**CITY OF EAST PROVIDENCE  
WATER MAIN CLEANING AND LINING PHASE V REBID  
RFP EP23/24-26R**

**ADDENDUM # 2 – OCTOBER 9, 2024**

The following revisions, clarifications, additions and/or deletions are hereby made a part of the Bid Documents for the City of East Providence's Water Main Cleaning and Lining Phase V Rebid project, RFP EP23/24-26R.

C3.1  
SHEET NO. 15 OF 28

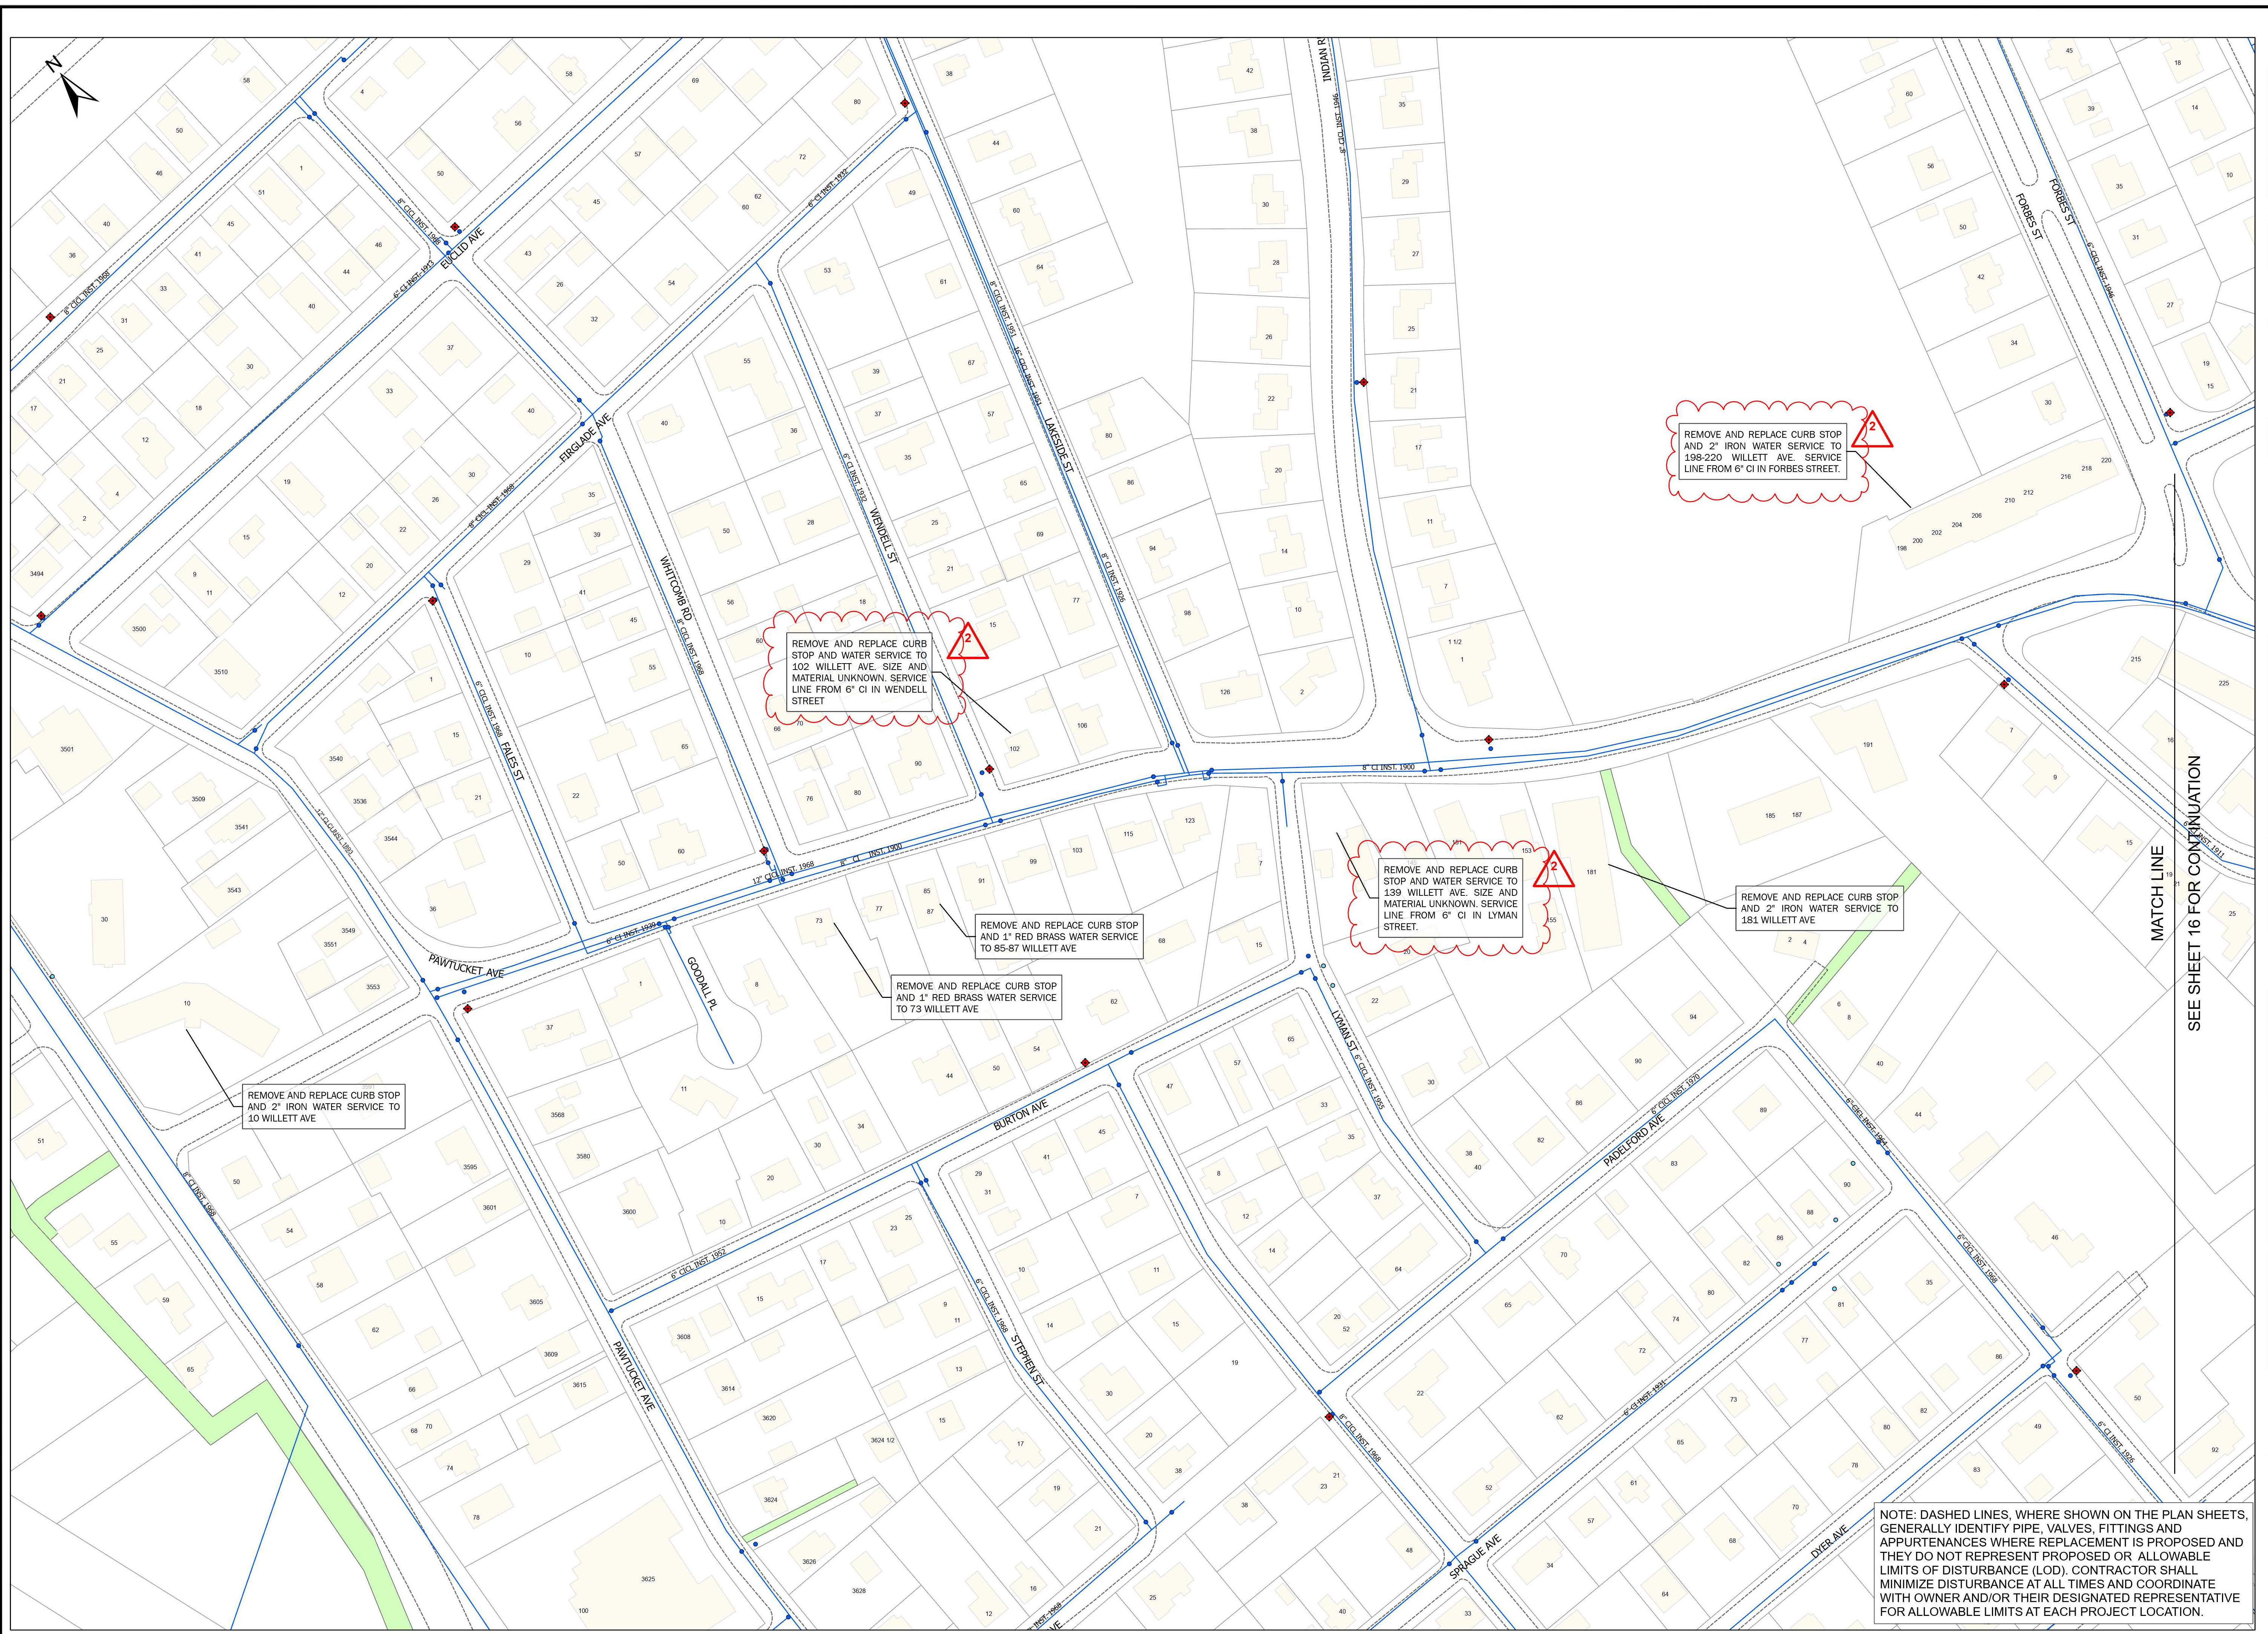
1. Please identify which main the 39 new services are off of on Willett Avenue.

**Service tie cards are provided as Attachment 1 of Addendum No. 2 for services connected to Willett Avenue. Sheets C3.1 through C3.4 have been revised to clarify which services are fed from side streets instead of the water main in Willett Avenue. These drawings have also been revised to show service replacements at 378, 595, 830, and 879 on Willett Avenue which were not previously identified. Bid quantities for service replacement and concrete base have been revised to reflect these changes. Please refer to attached Bid Form and Sheets C3.1 through C3.4 revised by Addendum No. 2.**
